STAFF REPORT KETCHUM PLANNING AND ZONING COMMISSION REGULAR MEETING OF JULY 13, 2021

- APPLICATION TYPE: Preapplication Design Review
- APPLICANT: Daniel Hollis, HR Architects, LLC (Architect)
- **PROPERTY OWNER:** SV Ventures, LLC
- **REQUEST:** Preapplication Design Review for the development of a new, 11,423 square foot, three-story multi-family building
- LOCATION: 780 N 1st Avenue Ketchum Townsite: Block 33: Lot 5
- **ZONING:** Community Core Subdistrict 2 Mixed Use (CC-2)
- **REVIEWER:** Morgan R. Landers, AICP Senior Planner

Exhibit A: Lofts at 780 – Cover Letter and Response to Department Comments

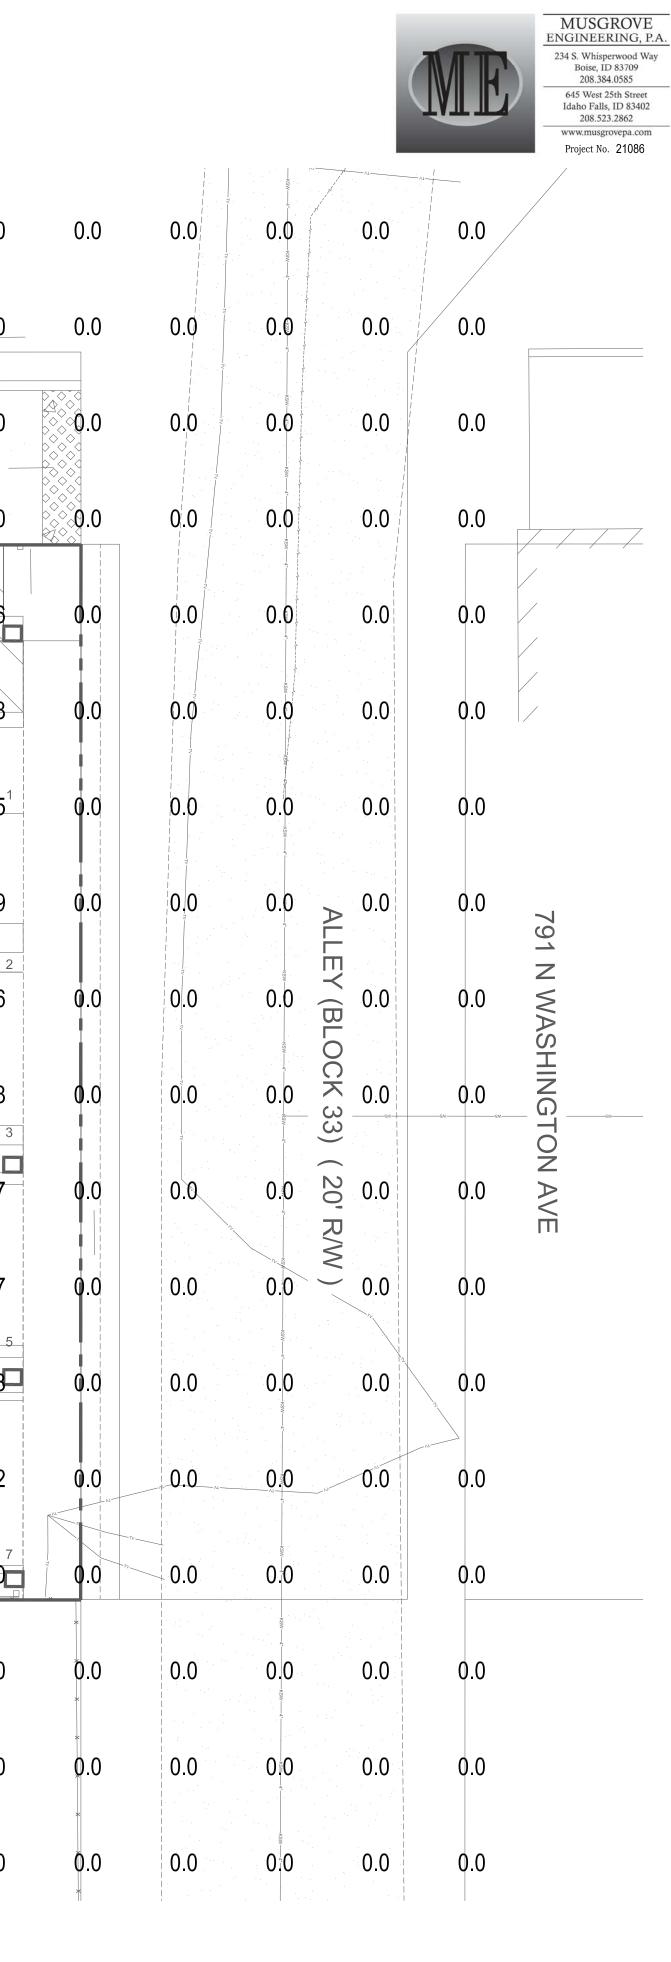
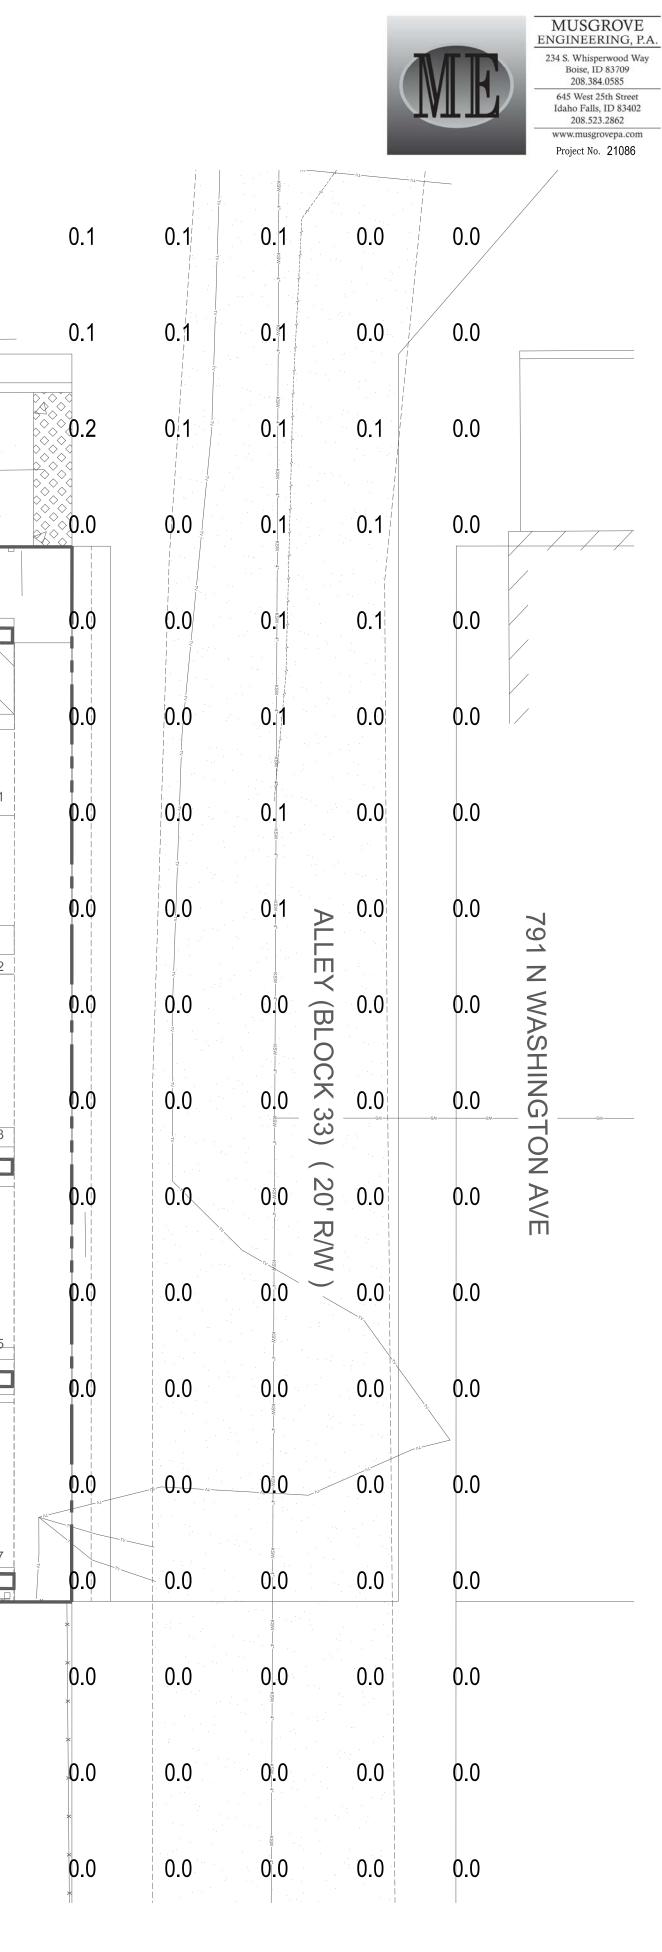
• <u>Illumination</u> – Staff understands the corner art installation on the retaining wall to be a low-level back-lit element. Please confirm that the photometric plan took this light fixture into account. Additionally, please provide information on the times of day the illumination is intended to be activated.

1 - Street trees are not required for this project, however, see the landscaping section of this memo for additional comments. Street lights are required per the City of Ketchum's "Right-of-Way and Lighting Standards" included as Attachment C to this letter. The standards outline the approach to streetlight placement and design based on illumination. Please revise the lighting plan to reflect the addition of the streetlights per the standards.

Refer to Electrical drawings that show updated photometric study that indicates placeholders for two street lights for the project. Exact location of these street lights will be based on where the streets department would like them.

Refer to revised Photometric plan by Musgrove engineering.
